**RE: Response to Peer Review  
58 Follette Street, Grafton MA  
By EcoTec, Inc. Memo Dated 11-17-2022**

ProTerra Design Group, LLC (ProTerra) received the Memo from Arthur Allen of EcoTec, Inc. peer review comments dated November 17, 2022. This letter is provided as a response to the comments and recommendations of the review of the raw land cell tower site located at 58 Follette Street in Grafton, Massachusetts. The numbered items below correspond to comments within the memo. The responses are in [blue](#).

58 FOLLETTE STREET  
 GRAFTON, MA 01519  
 SCALE: 1" = 20' DATE: DECEMBER 8, 2022

DRAINAGE  
 SKETCH PLAN

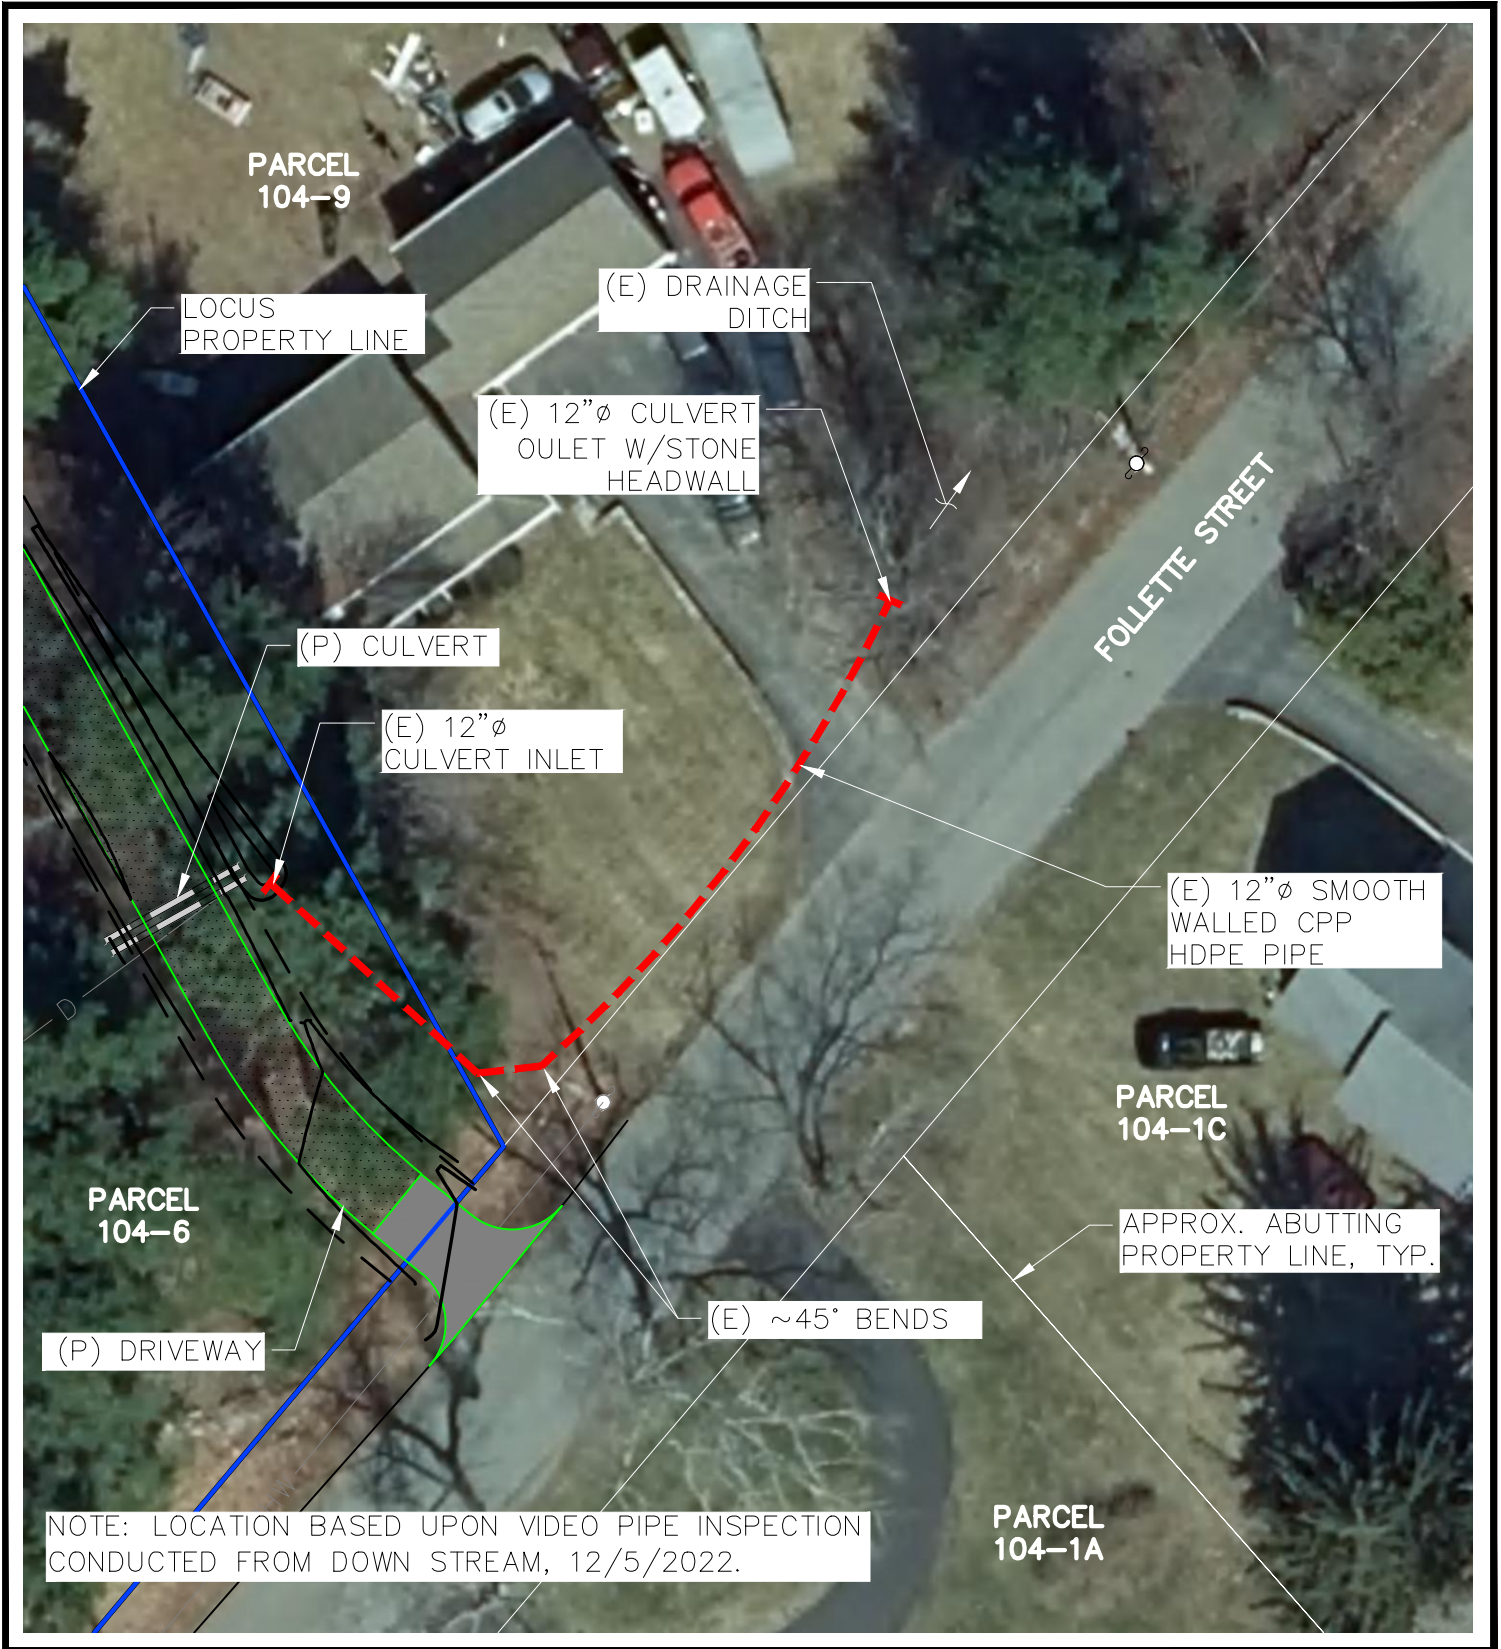
5. The wetland drains via an existing, 12-inch corrugated plastic culvert located between wetland flags A-8 and A-9. This culvert appears to have been installed to facilitate the development of 56 Follette Street as it extends approximately 100-feet underground between Follette Street and house No. 56 before daylighting on the east side of No. 56. The culvert appears to turn with no visible manholes. The design and installation of this culvert is questionable and I recommend against permitting new development discharging to it without

confirmation of its design, condition and functionality. Repair or replacement of the culvert should be made as necessary to ensure its long-term functionality.

We engaged Pipe Explorers, LLC video pipe inspection services to review the existing 12" culvert to determine the condition and approximate location along 56 Follette Street. The culvert was estimated to be approximately 20 years old consisting of a double wall HDPE. Two 45 degree HDPE bend fittings were found to be installed per the attached sketch to parallel the road on the front of the lot to the discharge point in the existing drainage along Follette Street. The video inspection revealed no clogs, debris, or structural deficiencies and appeared in good serviceable condition. Light staining inside the pipe indicated typical flows at 1/3<sup>rd</sup> the depth or below. No flow was observed at our time of visit and no erosion appeared at the channel downstream.

NOTE: LOCATION BASED UPON VIDEO PIPE INSPECTION CONDUCTED FROM DOWN STREAM, 12/5/2022.
